Response to the Alameda County Environmental Health Services Comments on the Subsurface Investigation and Product Recovery Work Plan dated September 7, 2012;

ARCADIS U.S., Inc. (ARCADIS) has prepared this letter on behalf of CBRE – Global Corporate Services (CBRE) and the Volkswagen Group of America (VWoA) for the Volkswagen Automobile Dealership located at 2740 Broadway Avenue, Oakland, California (“the Site”). The Site is identified as Fuel Leak Case No. RO0000400 and GeoTracker Global ID T0600100227. This letter responds to comments provided by the Alameda County Environmental Health (ACEH) Services in a November 15, 2012 letter (“the ACEH Comment Letter”) regarding the Subsurface Investigation and Product Recovery Work Plan, dated September 7, 2012 (“Work Plan”).

Figure 1
Revised MIP Boring Locations

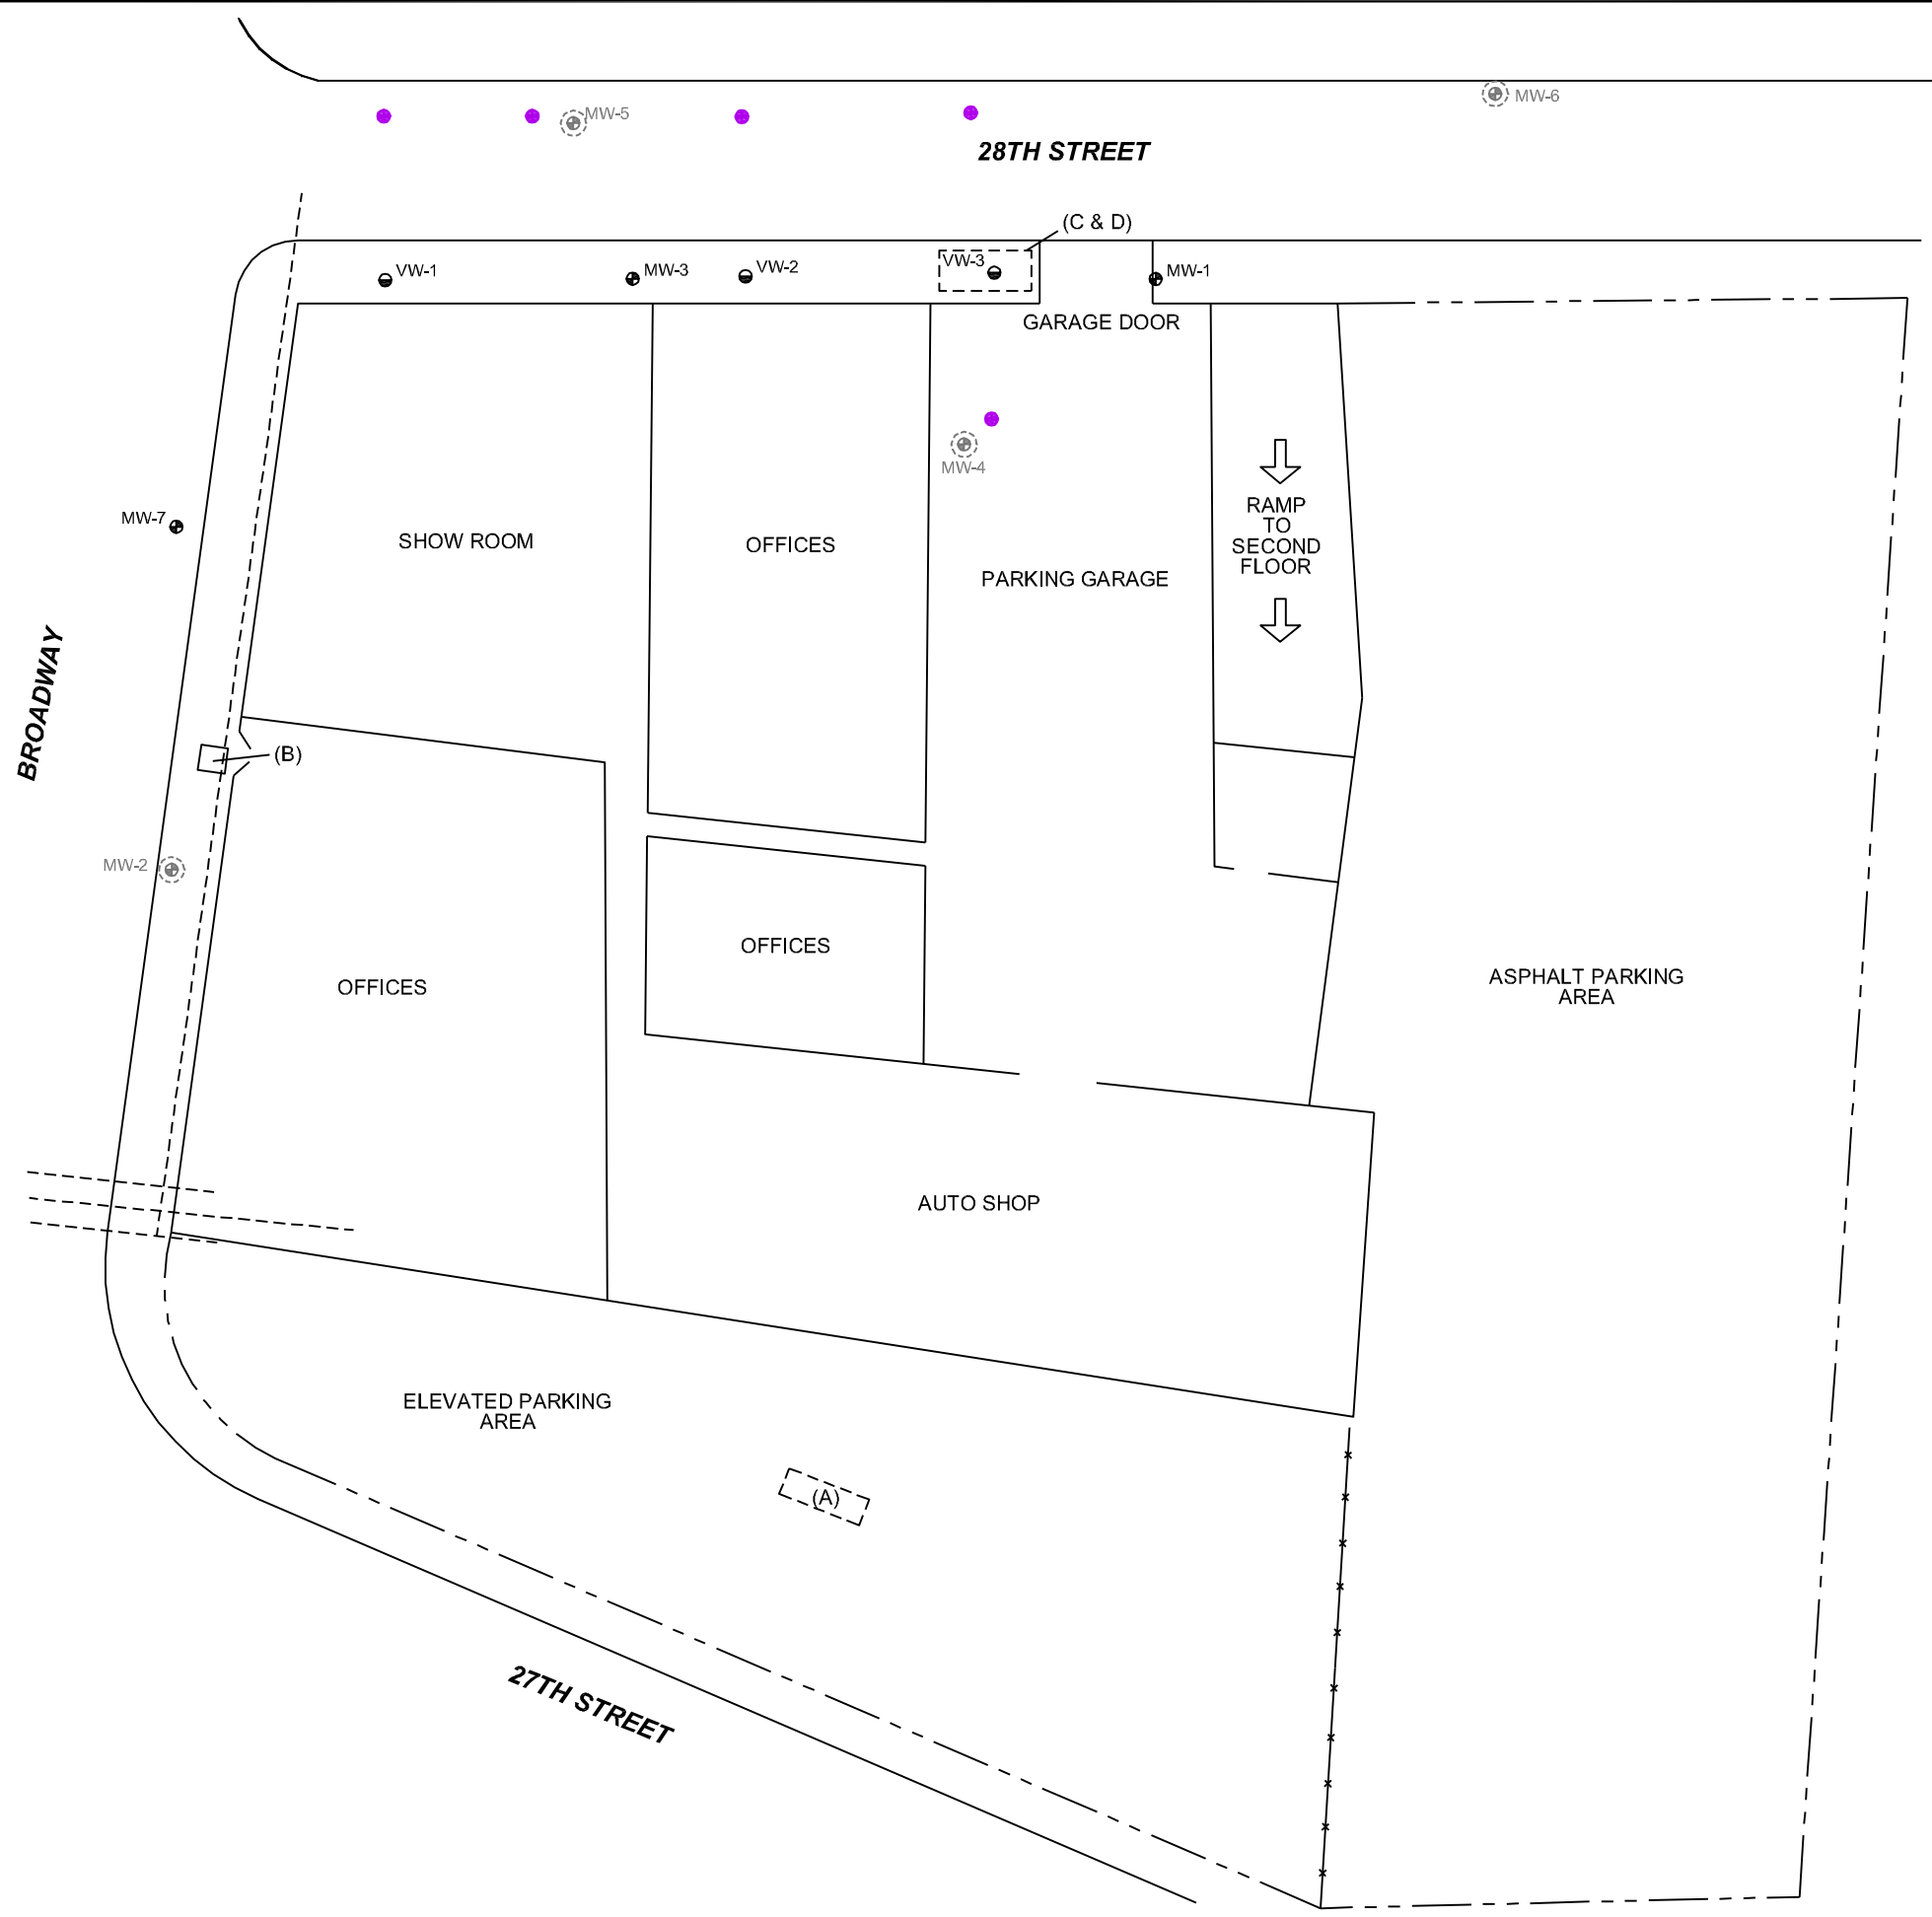
The proposed groundwater monitoring well locations should be based on the results of the MIP study. The borings that have the maximum concentrations should be the ones that are converted to monitoring points. In particular, the proposed well on Broadway appears to be a poor location based on the fact that VW-1 and MW-3 define the downgradient extent of the plume in that general direction. A well closer to former well MW-5 would seem to be more appropriate. Also, please adjust the spacing of your borings so that all four borings are more closely spaced, are positioned along a transect, and are all located on 28th Street. Submit a revised map to ACEH for approval prior to performing the borings. Then upon receiving the results of the MIP, please propose an appropriate location for the well based on those results.

The proposed locations for the MIP borings have been revised so that the four MIP locations proposed to be drilled along 28th Street are spaced closer together and in a transect on 28th Street (see Figure 1). The fifth MIP boring location is still proposed to be drilled near former groundwater monitoring well MW-4. The original Work Plan included the collection of grab groundwater samples from three of the five MIP boring locations. In an effort to better identify the locations for the future groundwater monitoring wells and based on the revisions described above, grab groundwater samples will be collected from each of the five proposed MIP locations.
